## PLAN COMMISSION MEETING AGENDA

TUESDAY, July 14, 2015  
AT 6:00 PM

# Plan Commission Report

**PROJECT:** Plan Review – Ron Boecker, Wheaton Franciscan Healthcare, Inc.

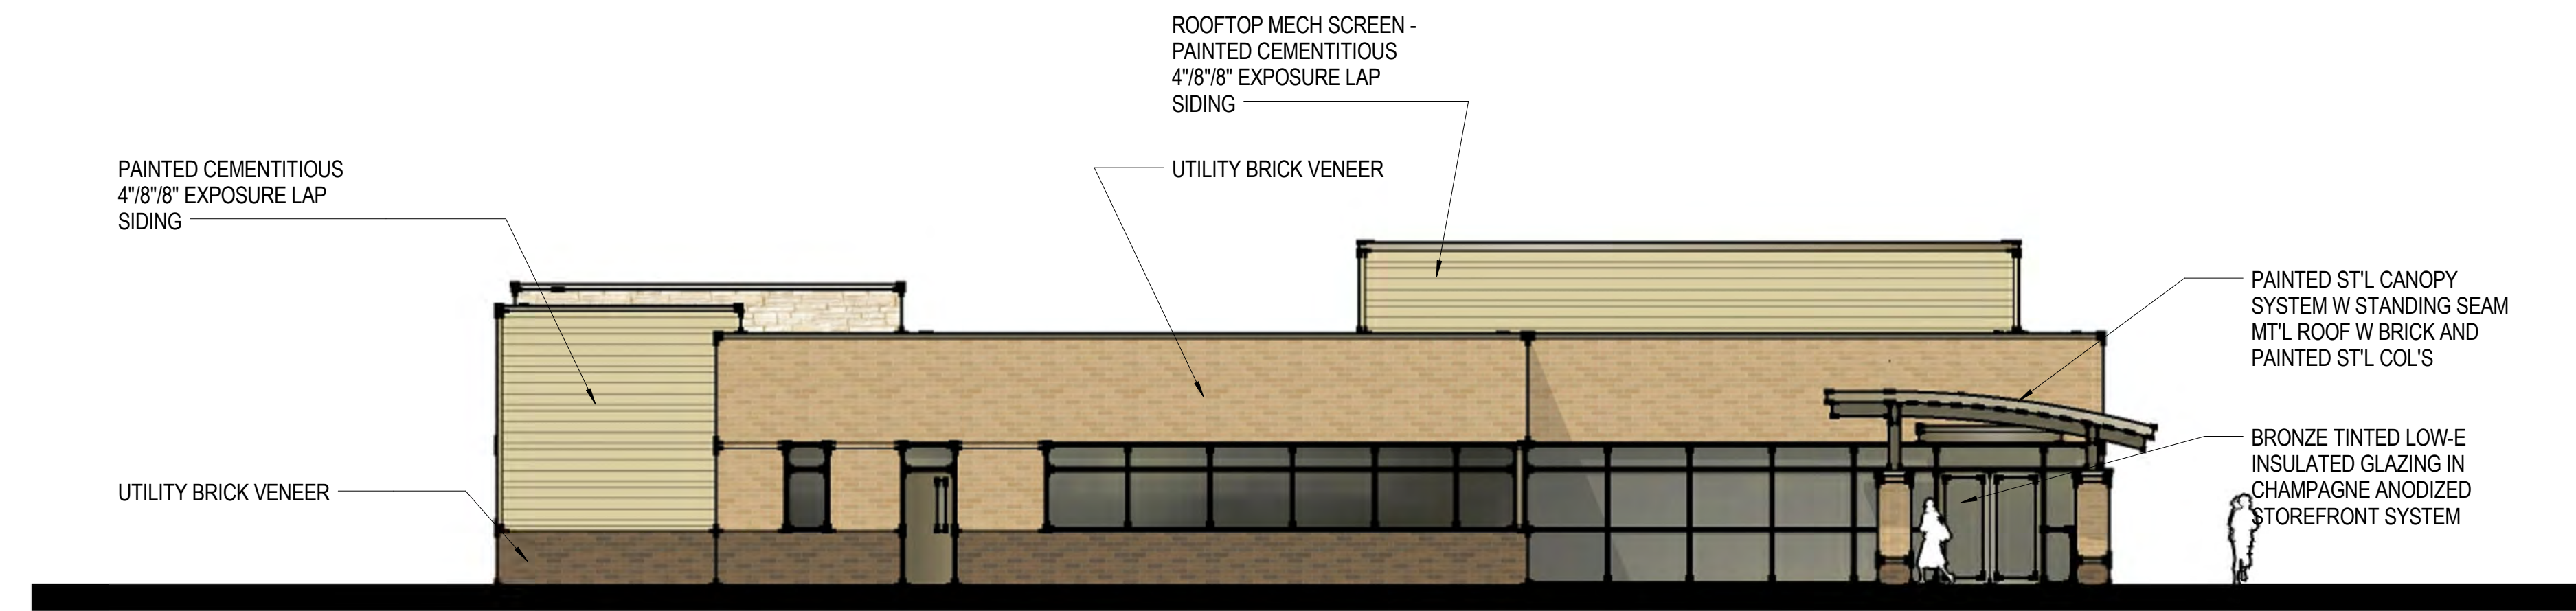
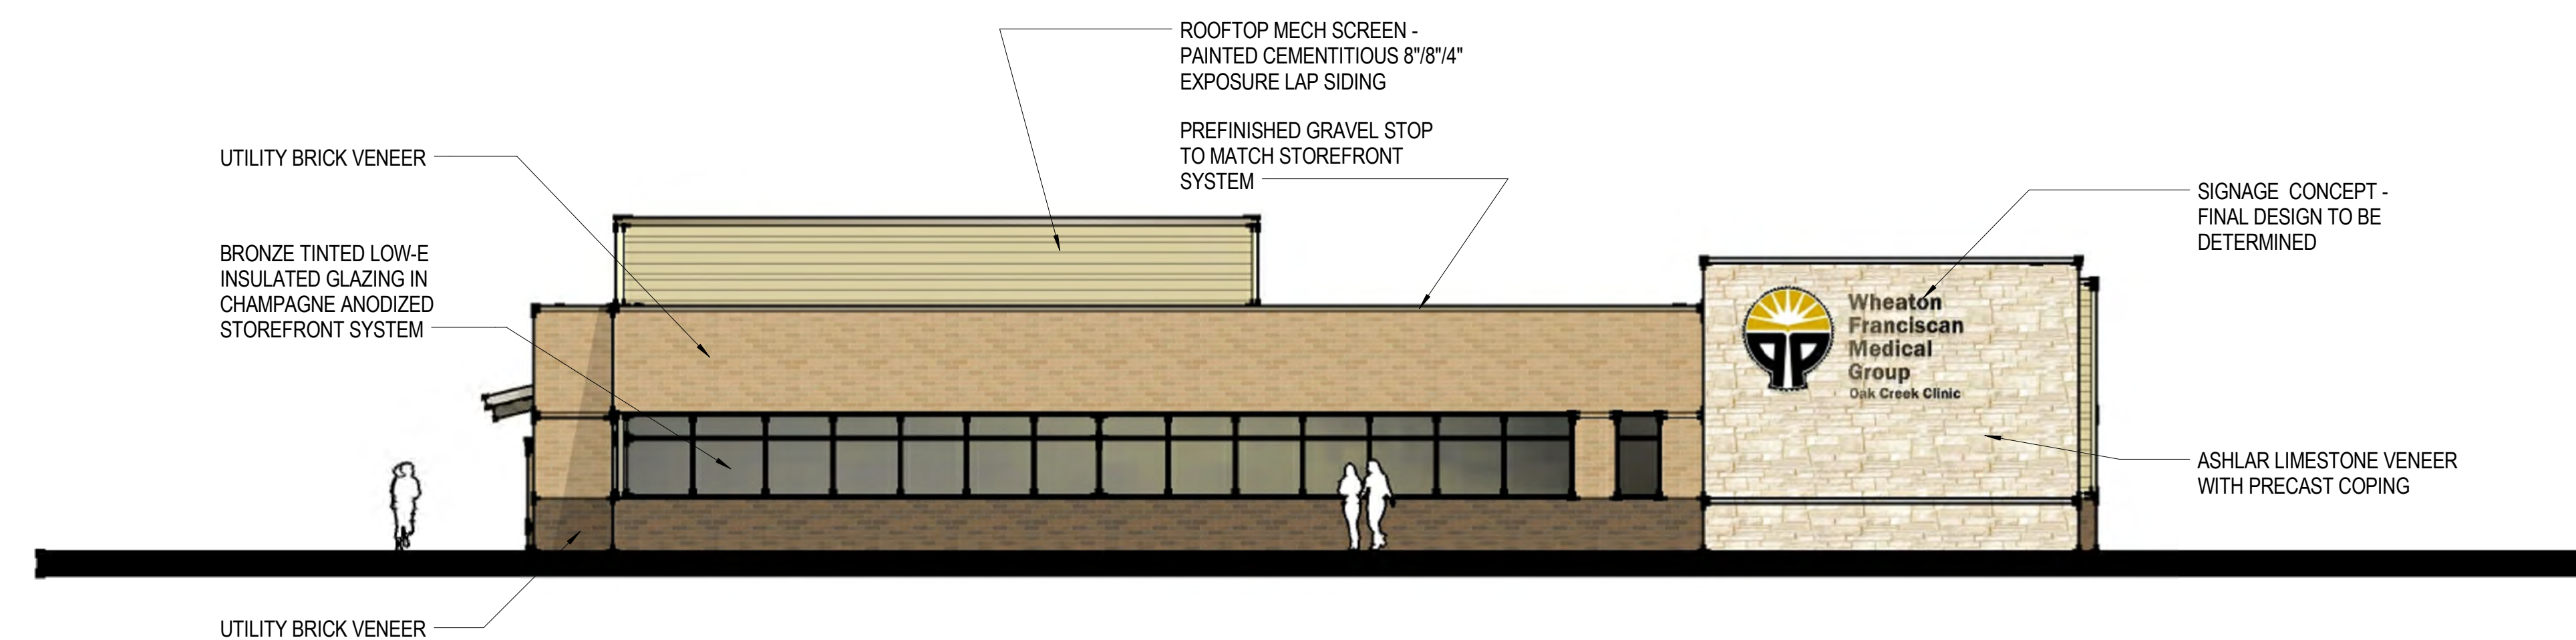
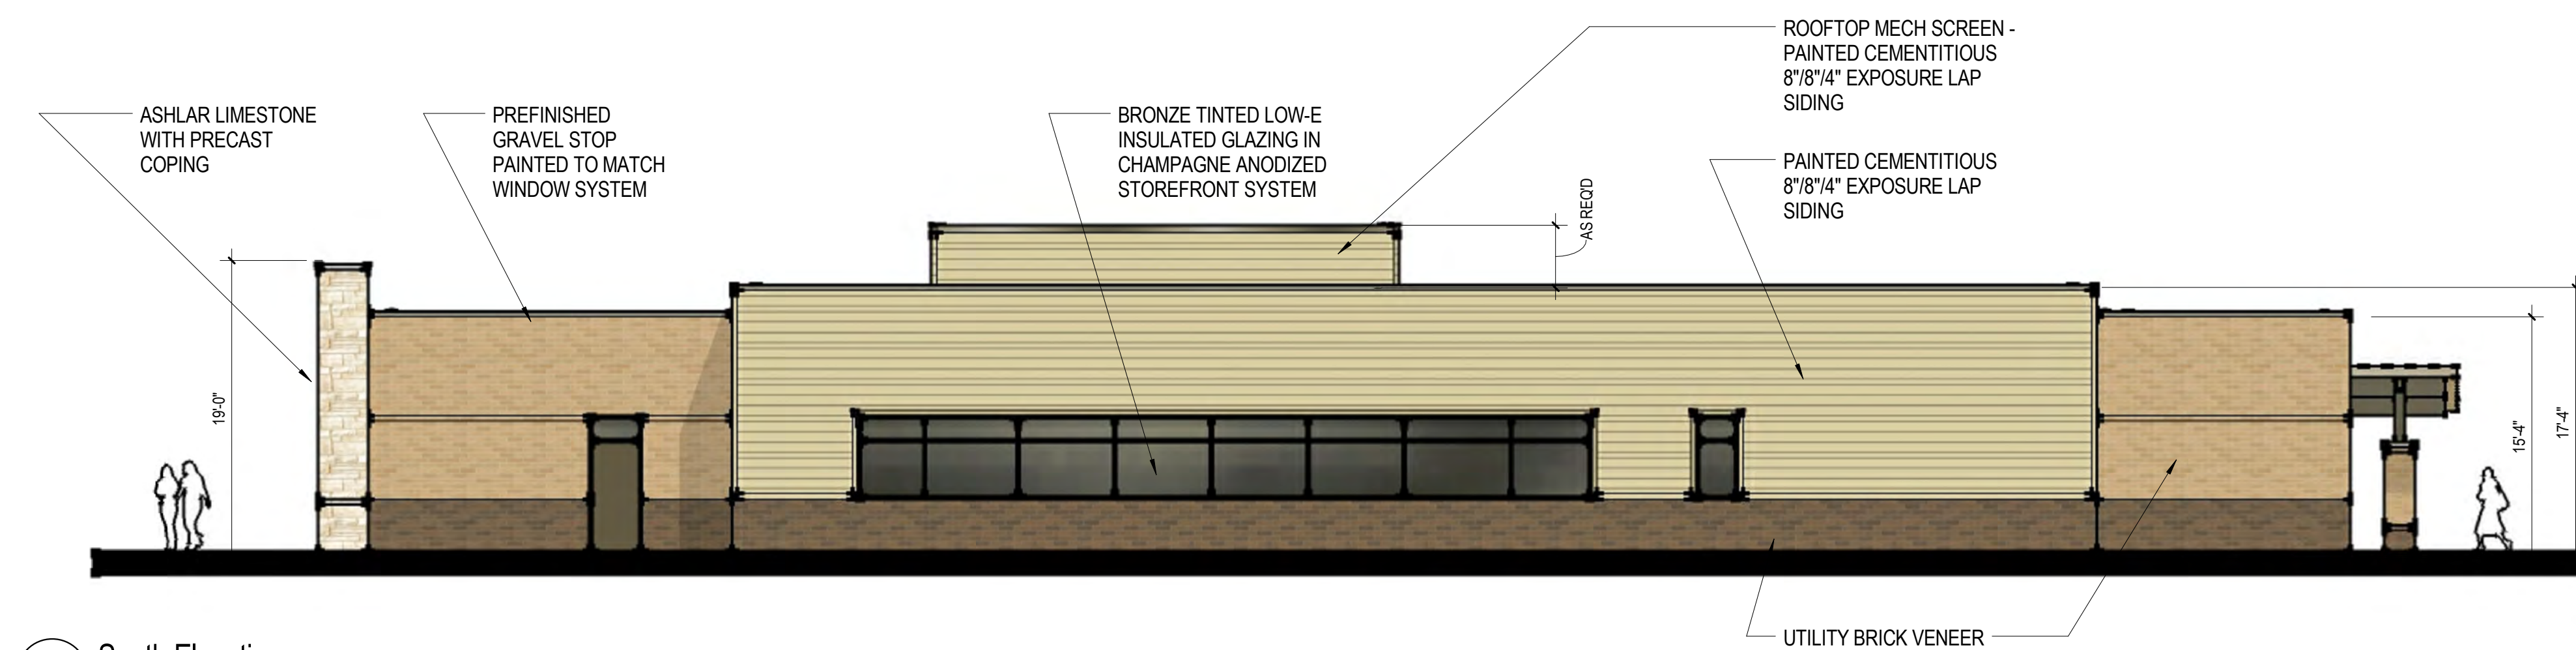
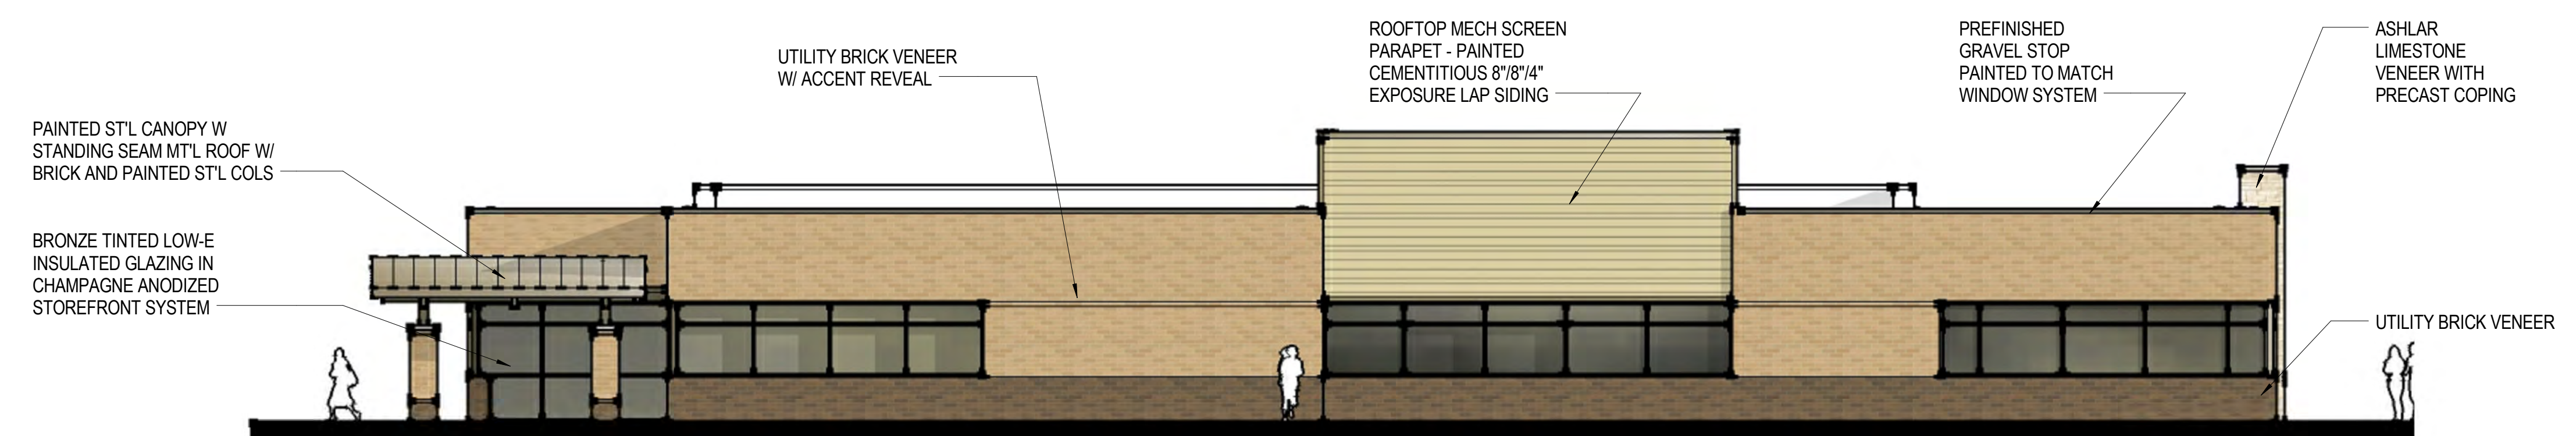
Cementitious lap siding is not listed as an acceptable exterior building material per Section 17.1009(a)(2). Therefore, a three-quarter (¾) majority approval of the Plan Commission will be required. Revisions to the exterior of the building since the initial submittal have reduced the amount of siding and increased the percentage of brick. Therefore, Staff recommends approving the use of lap siding as a non-primary building material.

1. Rooftop mechanical screen – Initially, a lap siding screen around the rooftop mechanicals was located in the middle of the roof. Upon revision, the screen was reconfigured into a parapet that begins in the middle of the north elevation and continues to roughly the middle of the roof.
2. The height of a portion of the south elevation (covered by lap siding) was raised two feet above the main roof to provide additional rooftop dimension.

LANDSCAPE PLAN,  
 SCHEDULE, NOTES,  
 & DETAILS

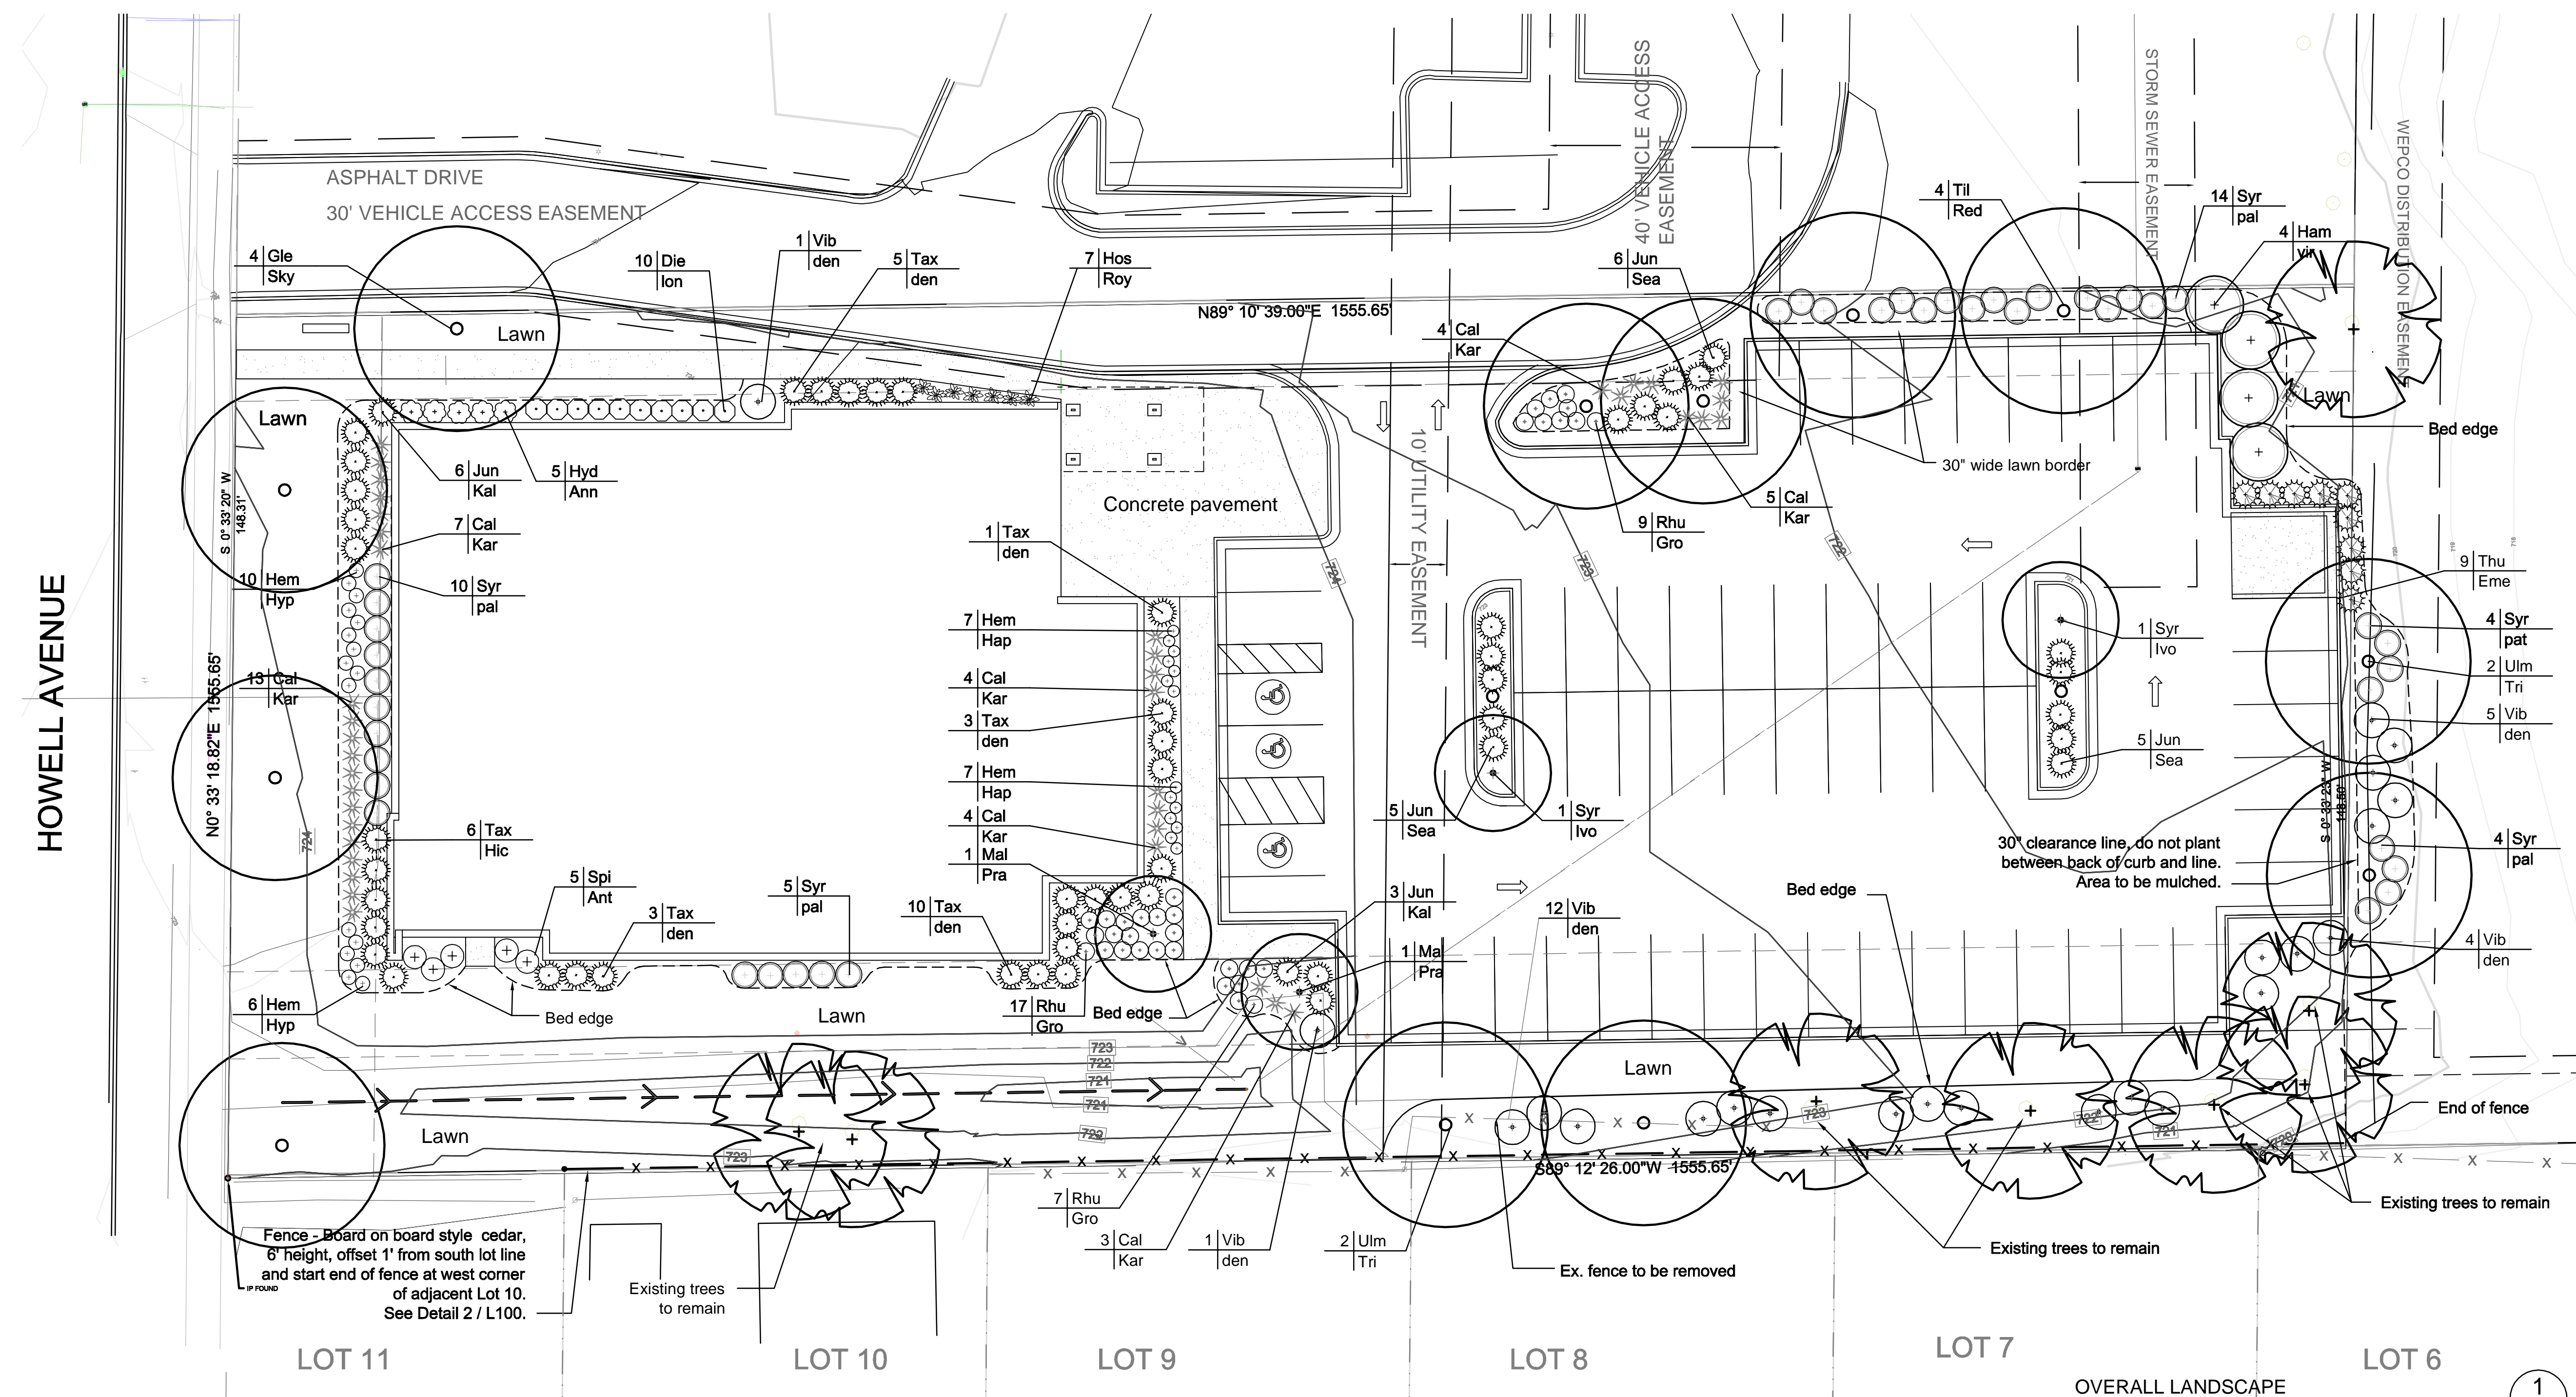
Landscape plans have been submitted detailing the locations of existing trees to remain, additional landscape treatments adjacent to the building and parking lot, and around two sides of the dumpster enclosure. Final approval of landscape plans are proposed to be approved by the Director of Community Development in the conditions above.

3. That all mechanical equipment (ground, building, and rooftop) is screened from view.
4. That revised landscaping plans are submitted for review and approval by the Director of Community Development prior to submission of building permit applications.
